{ Denotes changes to ADD. 98 - 10/15/76 CO ADD. 98 - 5/5/77

H-1 VIADUCT (WB)

INDEX TO DRAWINGS
ESTIMATED QUANTITIES

KEEHI INTERCHANGE
F.A.I. PROJ. NO. I-HI-1 (130): 17

RAMP I & II FRAMING PLAN

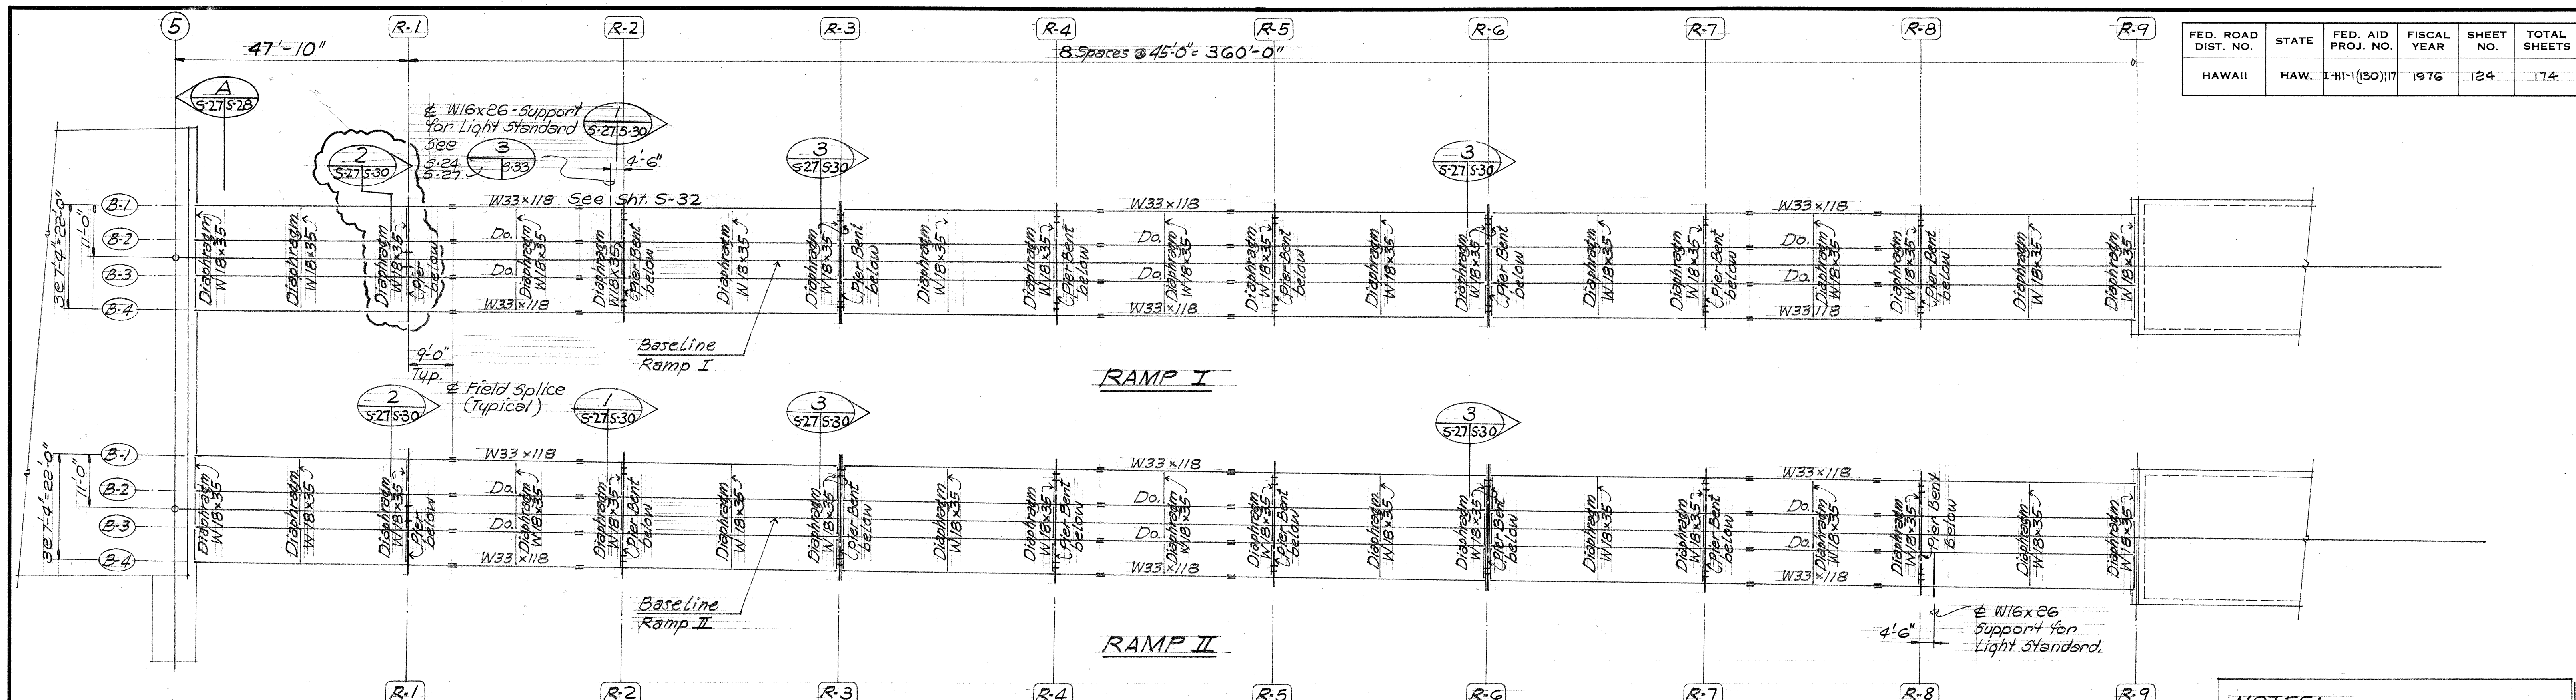
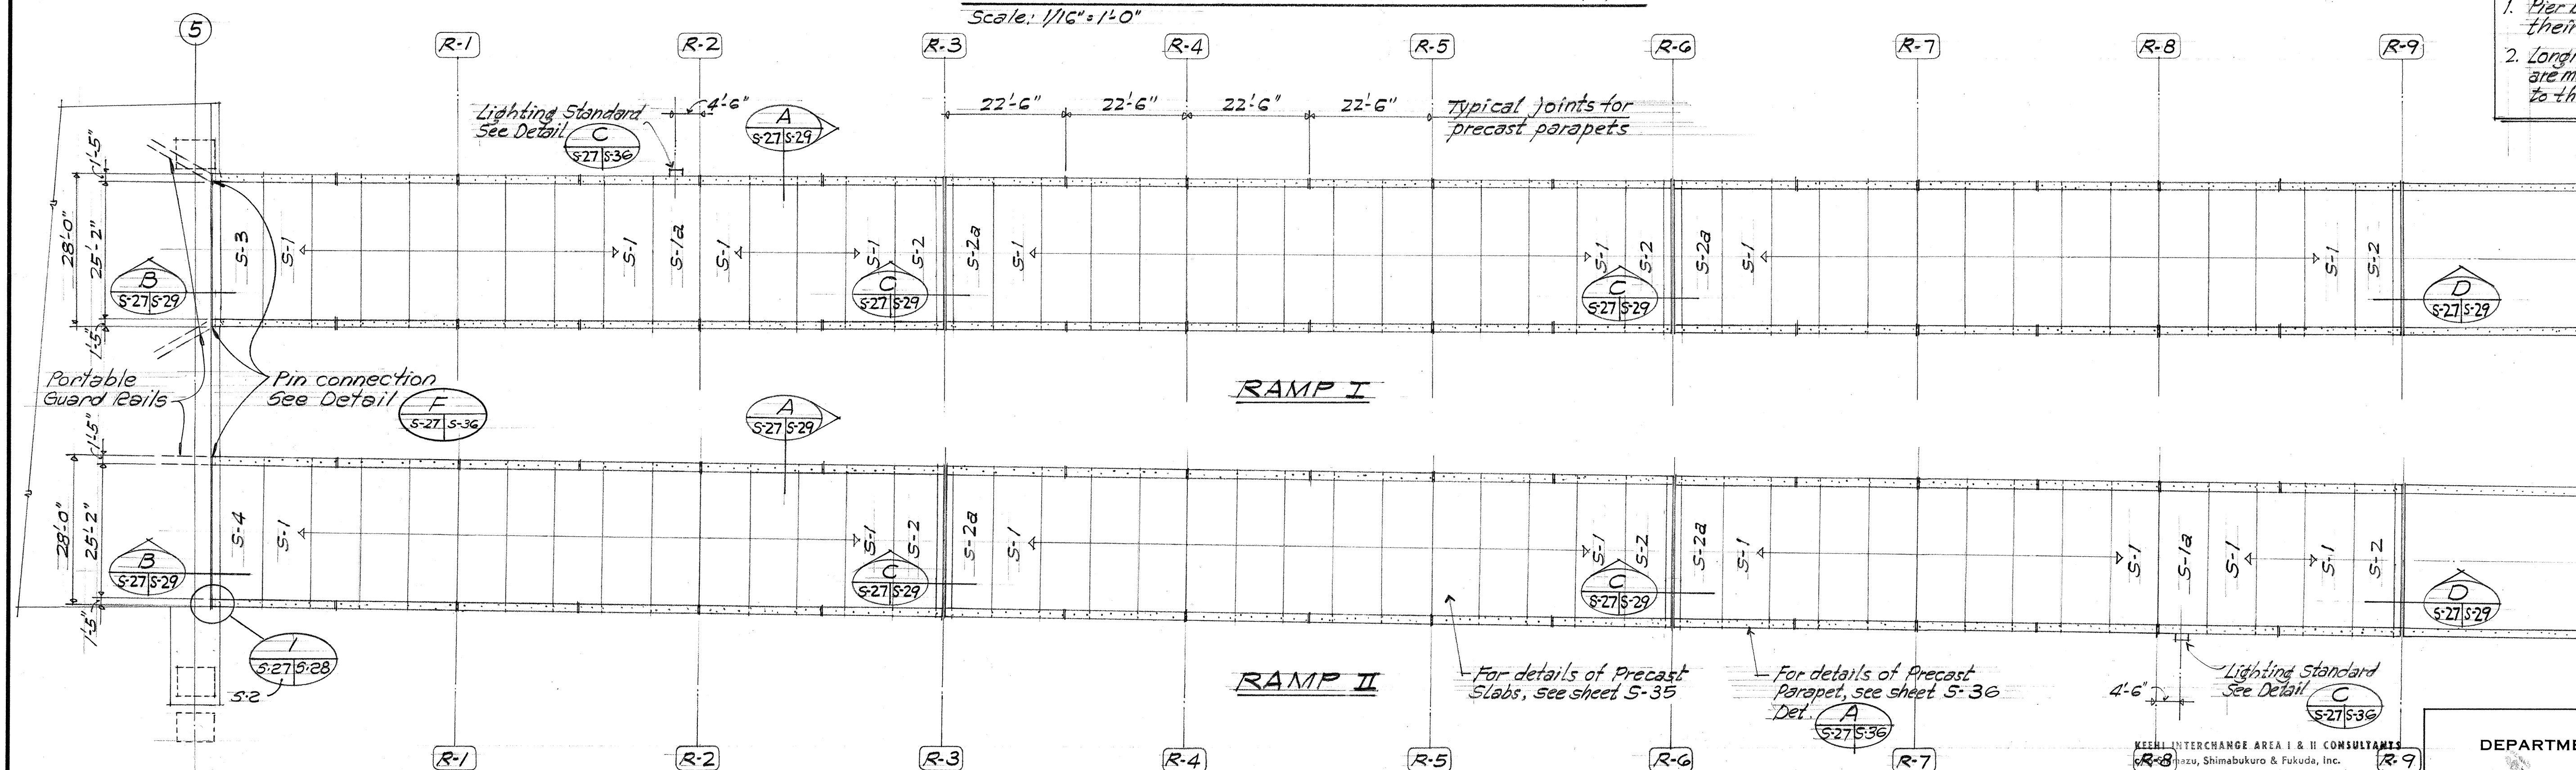
10/15/76	Revised to single column pier bent at Ramp I, (R-1)
DATE	REVISION

PIER BENT AT RAMP I & II LINE R-1

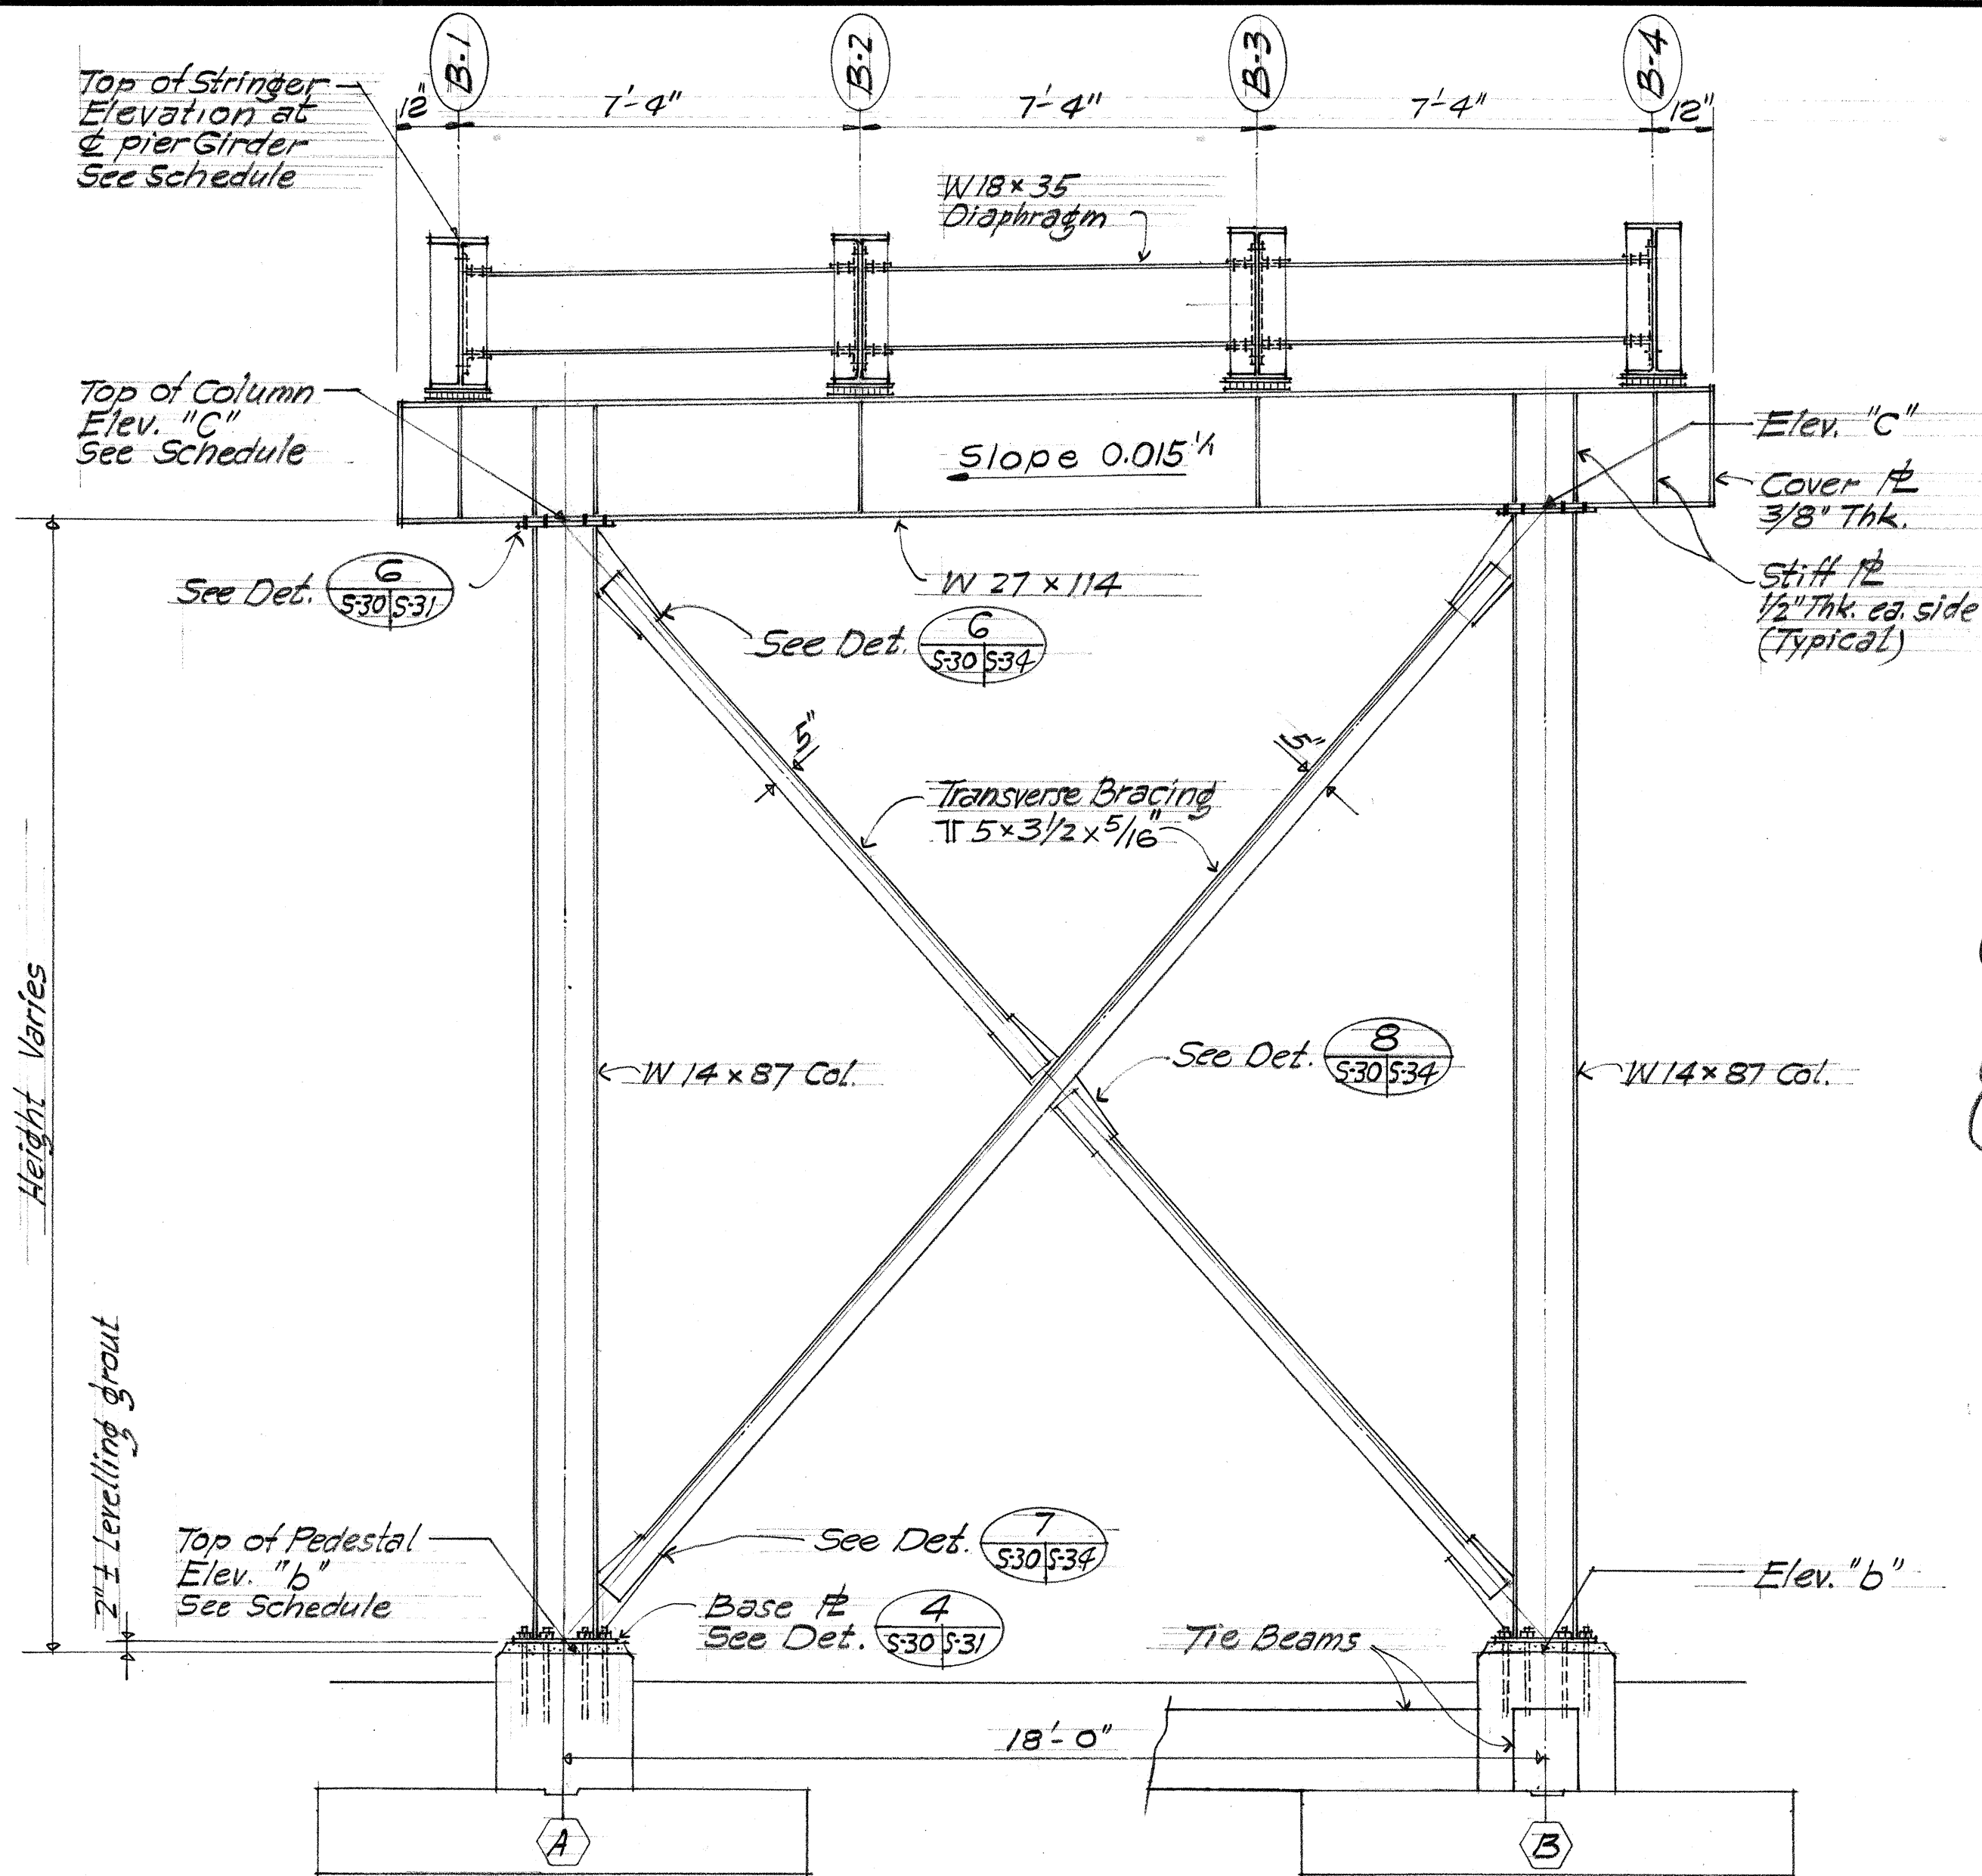
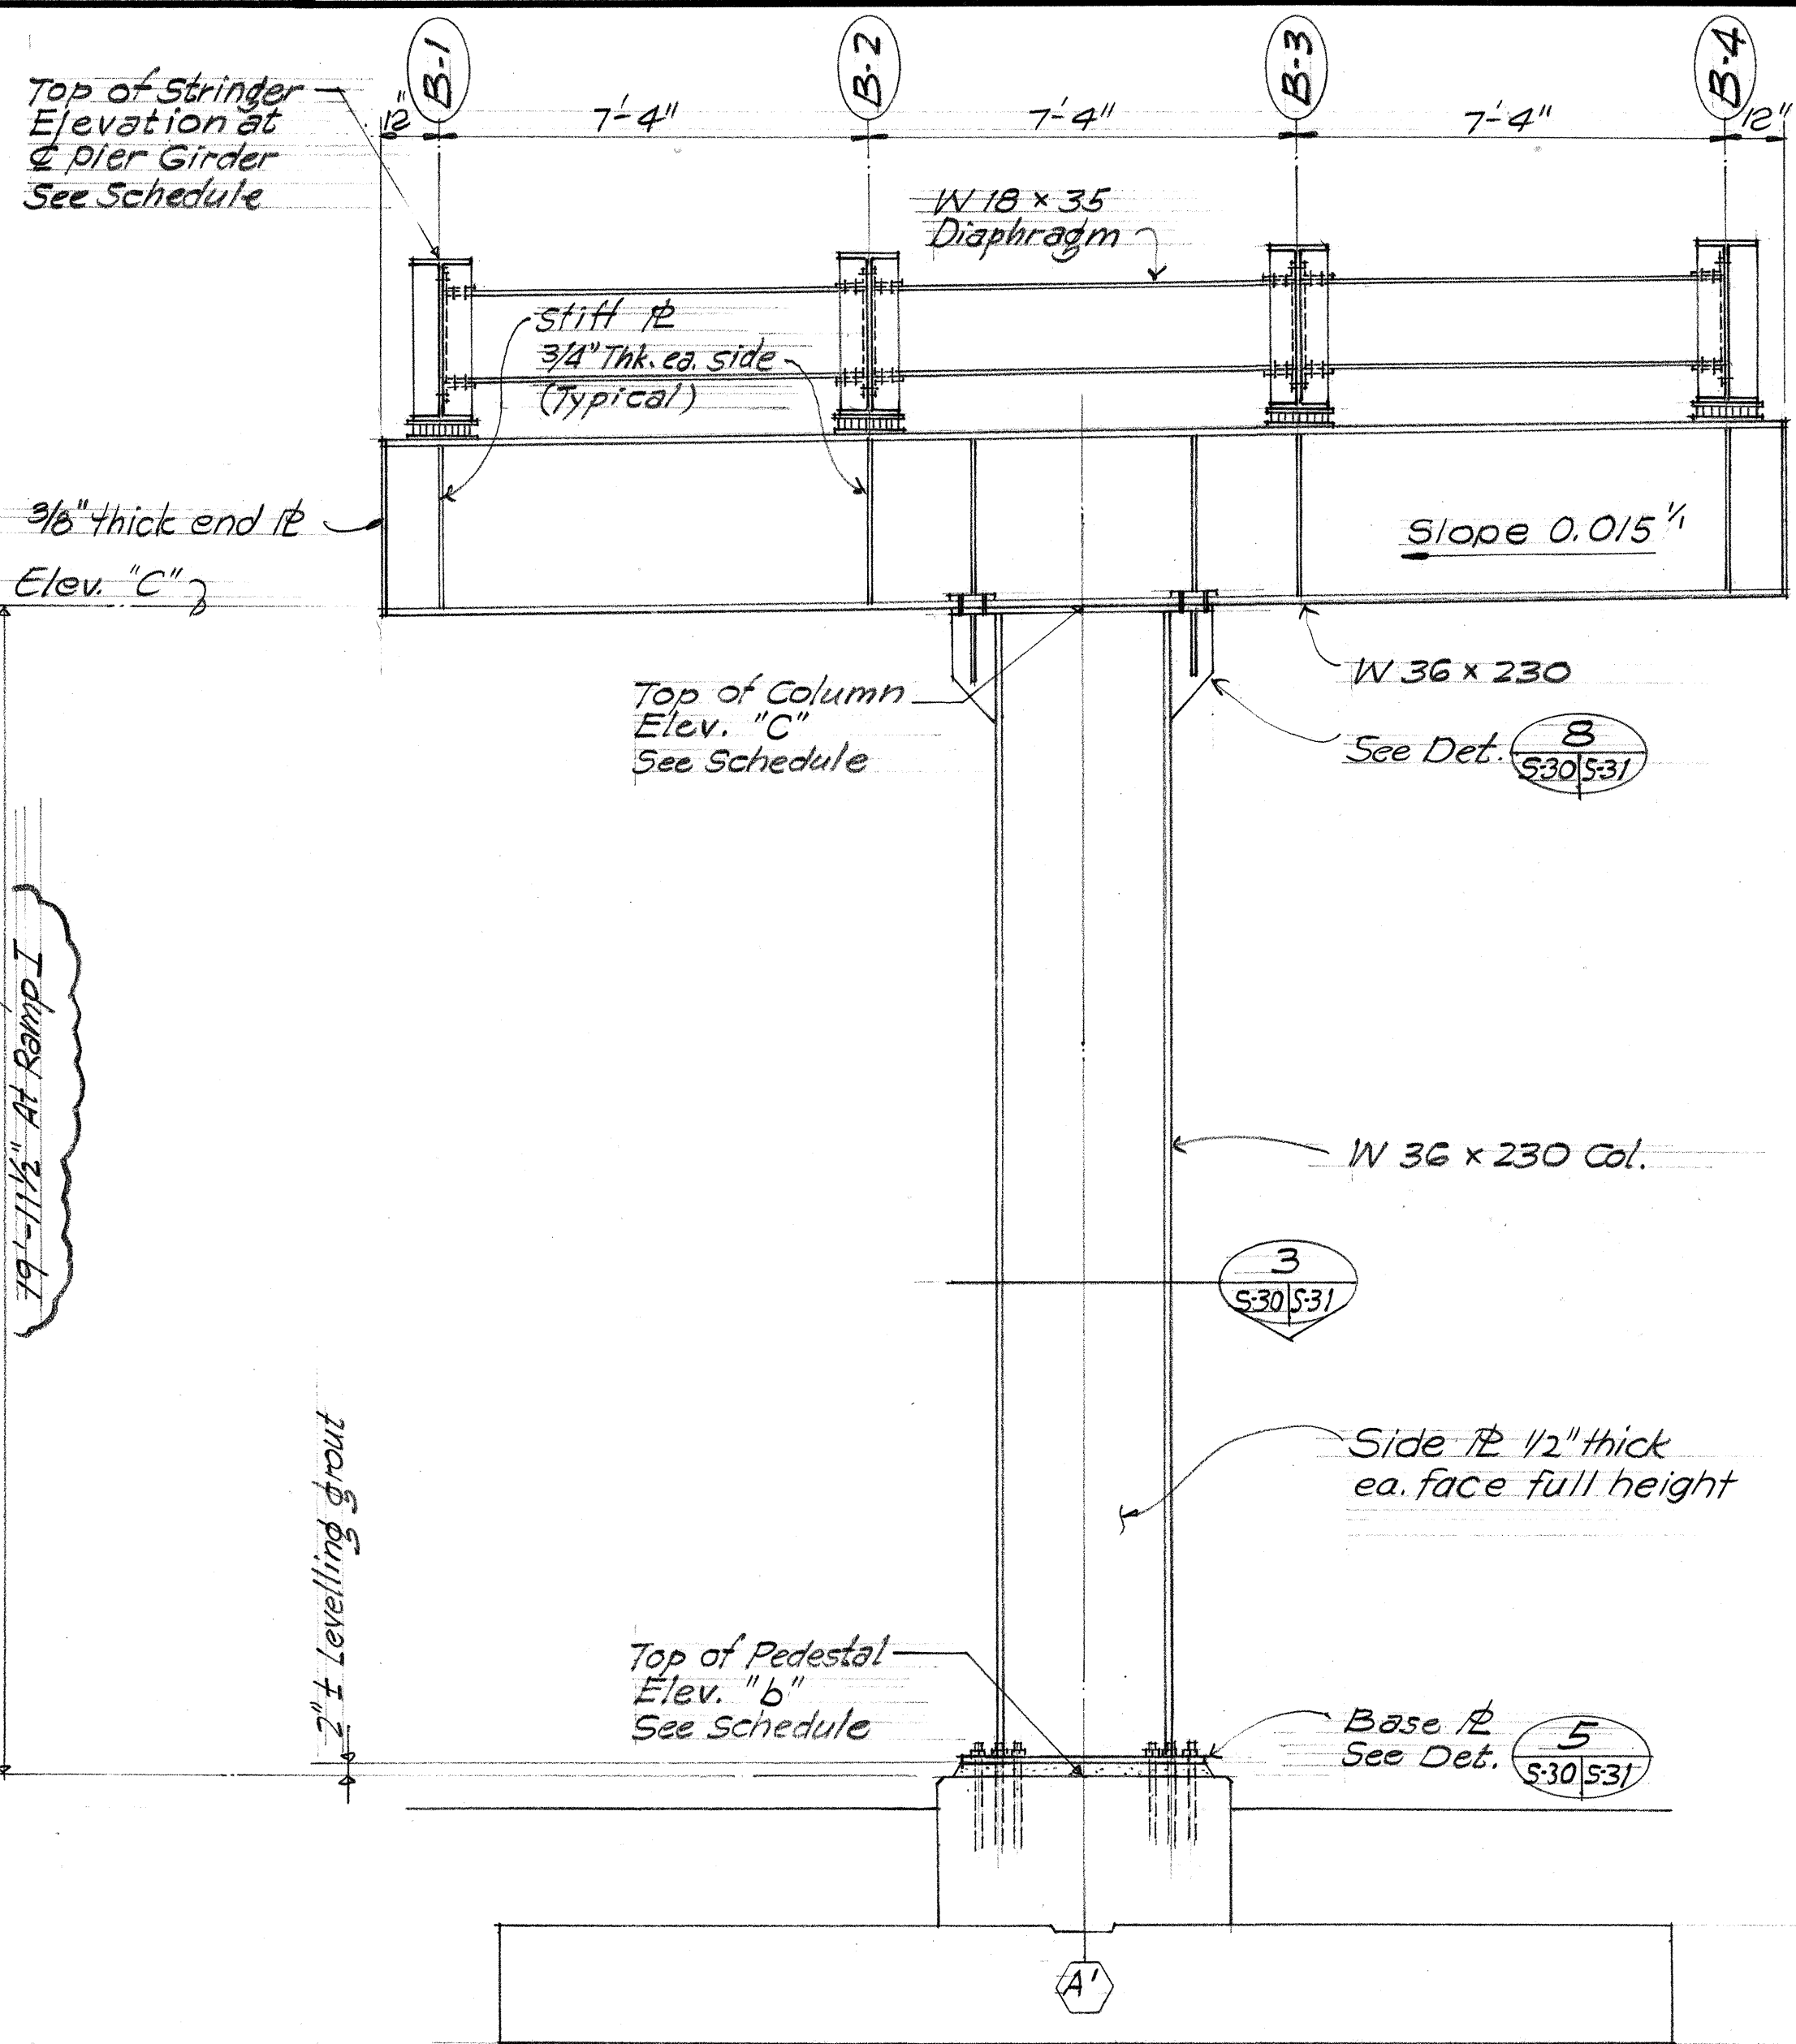
DATE	REVISION
10/15/76	Revised S30/S31 to apply to Ramp I & II. Corrected Ramp I, (R) Elevations.
